## ANN ARBOR HISTORIC DISTRICT COMMISSION

### Staff Report

**ADDRESS:** 106 South Main Street, Application Number HDC12-056

**APPLICATION:** The applicant seeks HDC approval to remove the existing infill windows and install a new storefront door and window openings.

## PROPOSED MAIN STREET ELEVATION

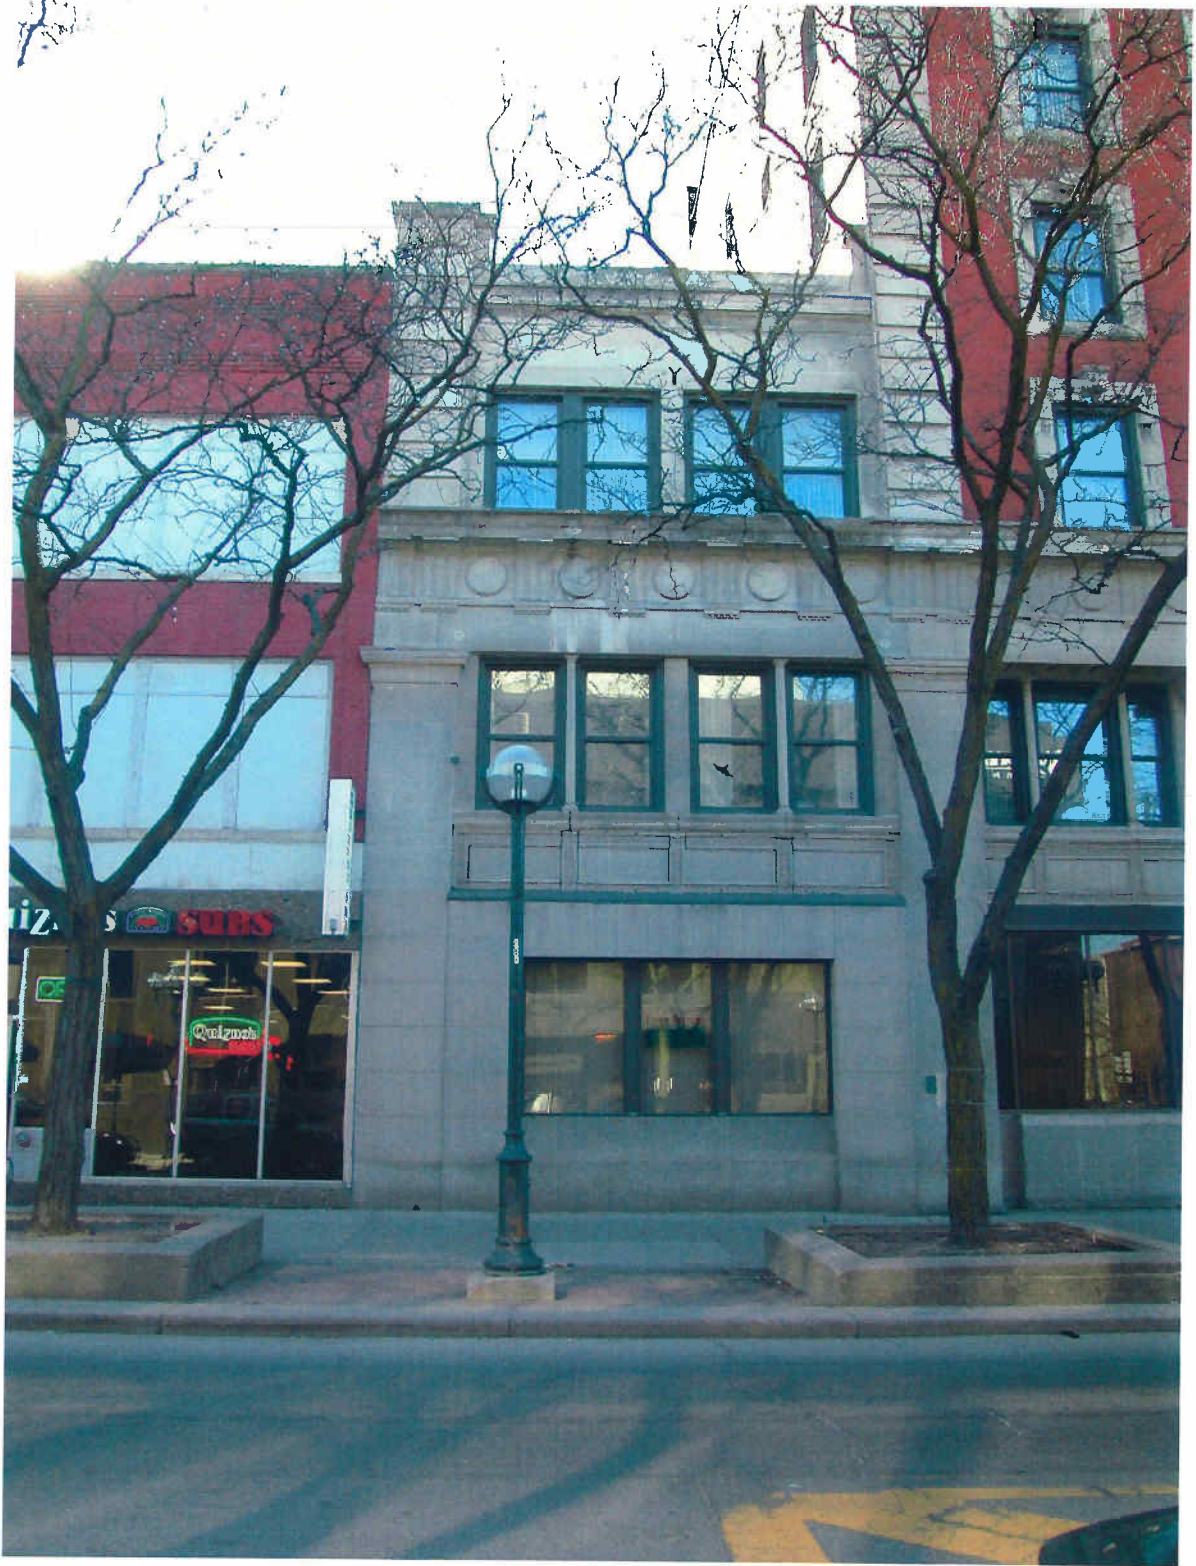
2. The proposed storefront will be the same width as the windows that are currently installed. It consists of a central door surrounded by a large window on each side and smaller windows above.

4. The proposed storefront is appropriately scaled and its placement in a previously infilled area is appropriate. On the provided photographic mock-up and schematic sketch, the

storefront appears to be compatible in size, materials, and color to the building. The storefront also appears to be well balanced and does not detract from the character defining features of the building.

5. Staff recommends approval of the proposed commercial storefront. The proposed storefront is generally compatible in exterior design, arrangement, texture, material and relationship to the rest of the building and the surrounding area and meets *The Secretary of the Interior's Standards for Rehabilitation*, in particular standards 1, 2, and 9, and the guidelines for storefronts.
